3.3 Wind-and Tornado and Hurricane Loadings

DCD_02-03
S01

MIC-03-03-
00057

3. DESIGN OF STRUCTURES, SYSTEMS, US-APWR Design Control Document COMPONENTS, AND EQUIPMENT

Figure 3.8.4-12 West PS/B Wall and Slab ~~Critical~~Representative Sections
(Floor Plan of 1F, EL 3'-7")

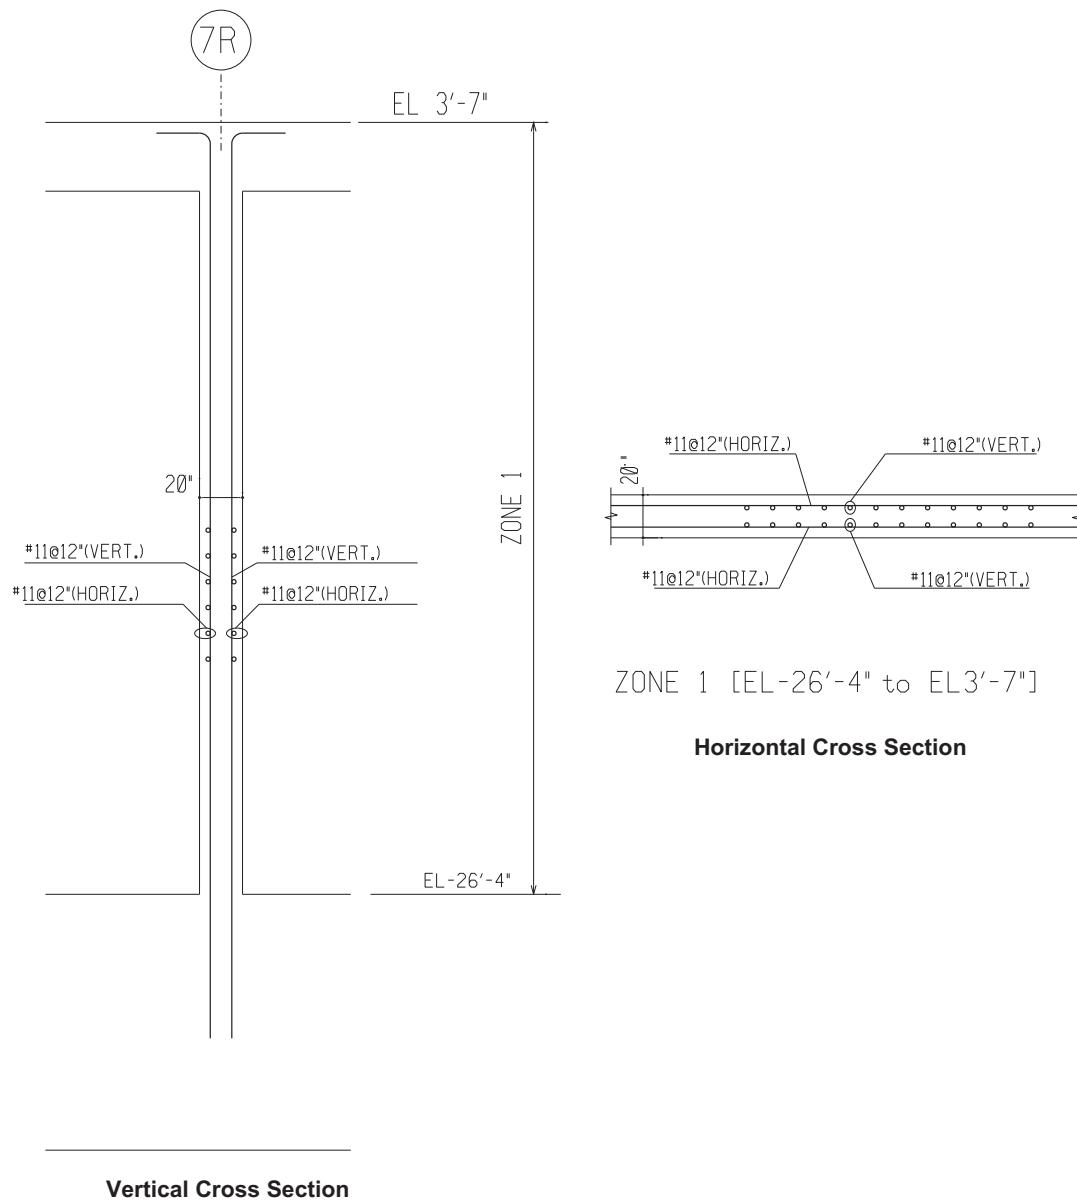
The concrete slab is designed for the applicable loads including dead load, live load, seismic loads, and thermal loads. The concrete slab is 32 in. thick. Table 3.8.4-14 presents the typical details of the reinforcement for AREA 1. Figure 3.8.4-15 shows the typical reinforcement at AREA 1, ~~which is applicable for the entire floor slab area in the PS/Bs~~

Figure 3.8.5-7 Global Three-Dimensional FE Model of R/B, ~~PCCV, and Containment Internal Structure Complex~~ (N-S Section)

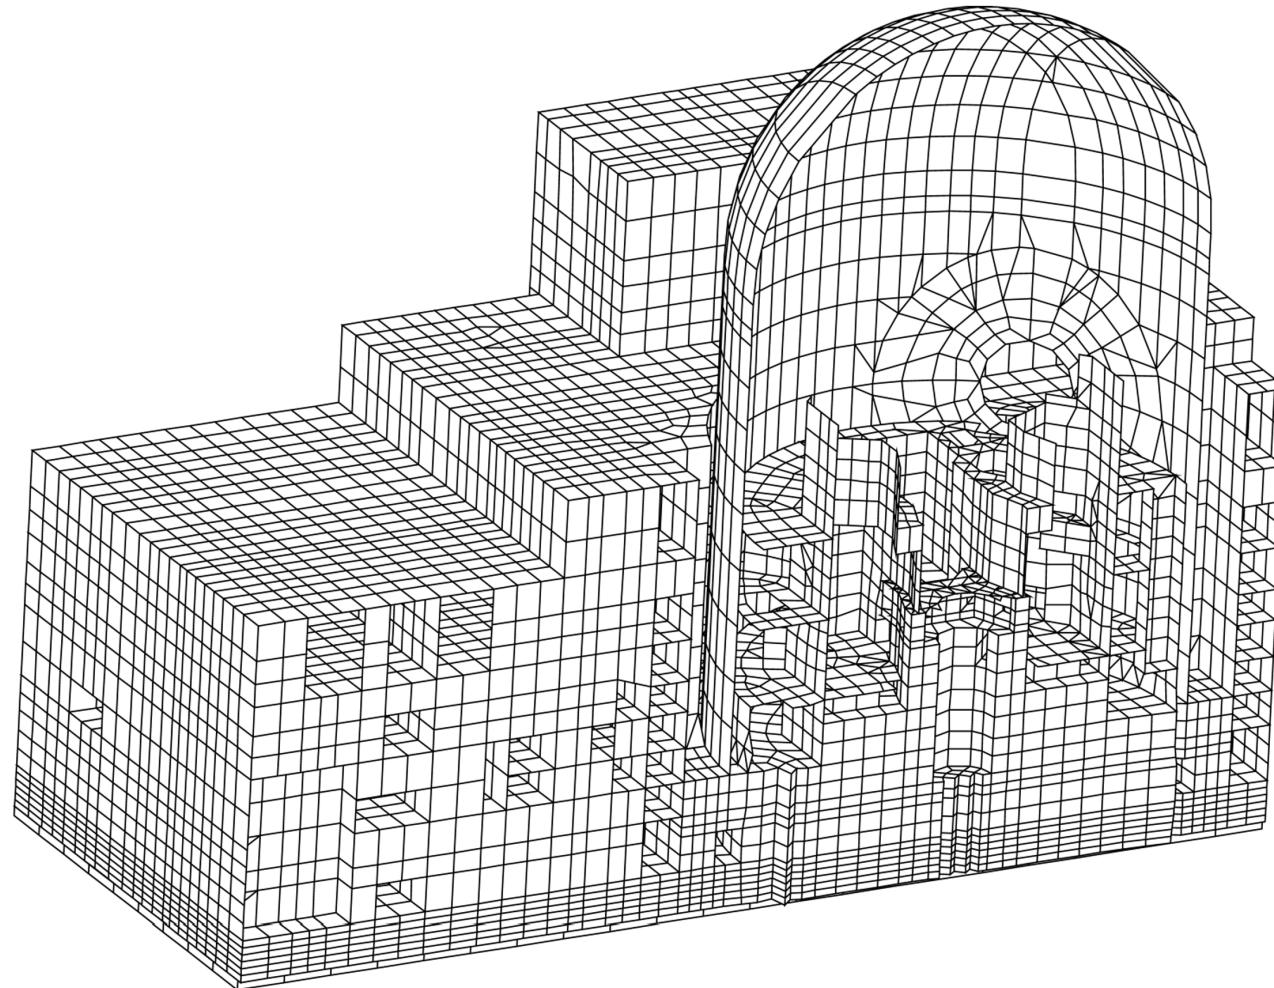
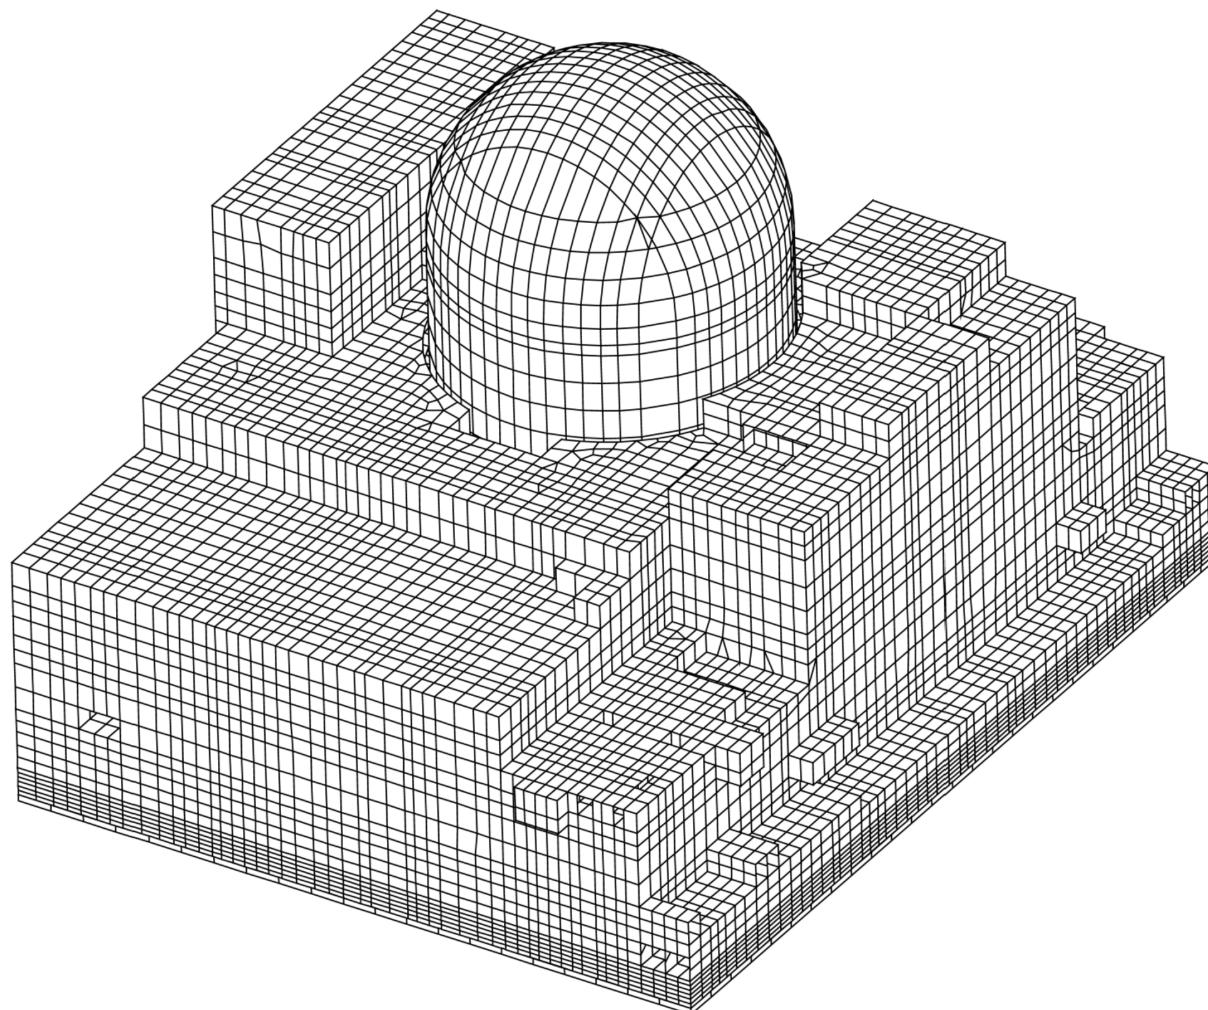
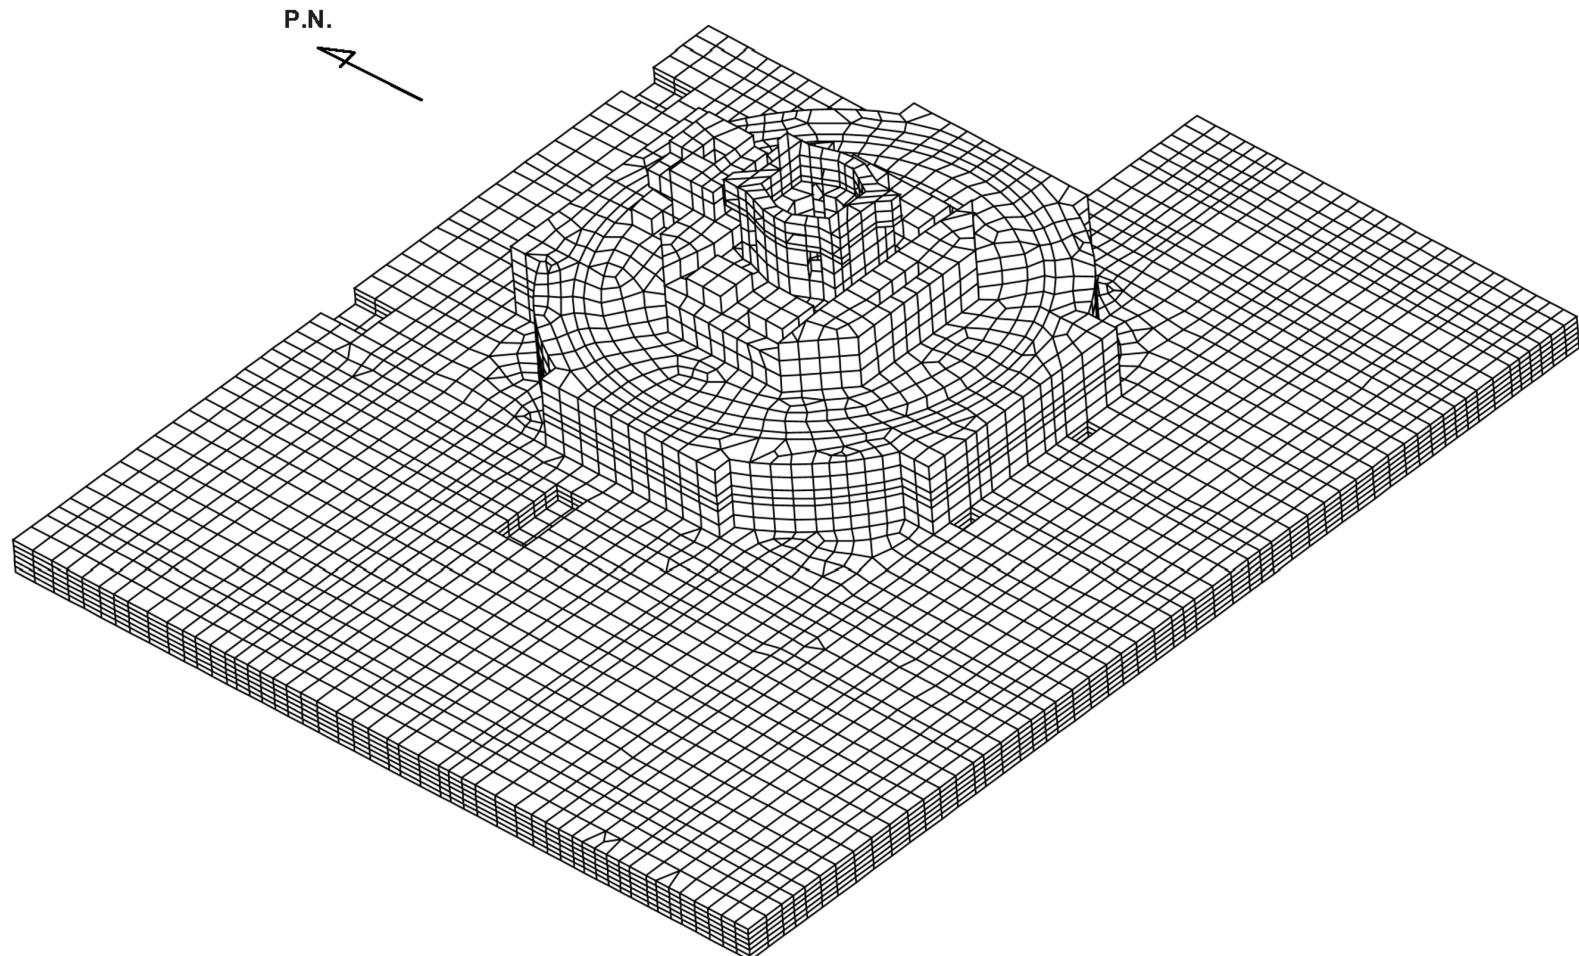
The three-dimensional global FE analysis model as represented in Figures 3.8.5-~~75~~, ~~through 3.8.5-810, and 3.8.5-9~~ includes the overall PCCV structure, as well as the R/B, ~~the east PS/B, west PS/B, A/B~~ containment internal structure and the common basemat to which all these structures are supported. The FEs used for the PCCV analyses (Figure 3.7.2-1) have membrane, bending, tangential, and radial shear capability. The model accounts for effective prestress equivalent to the variation of tendon friction due to losses or changing geometry, for example the inverted U-shape tendons' transition from cylinder to dome. In developing the model, the mesh size is chosen to comply with the following basic considerations and empirical checks.
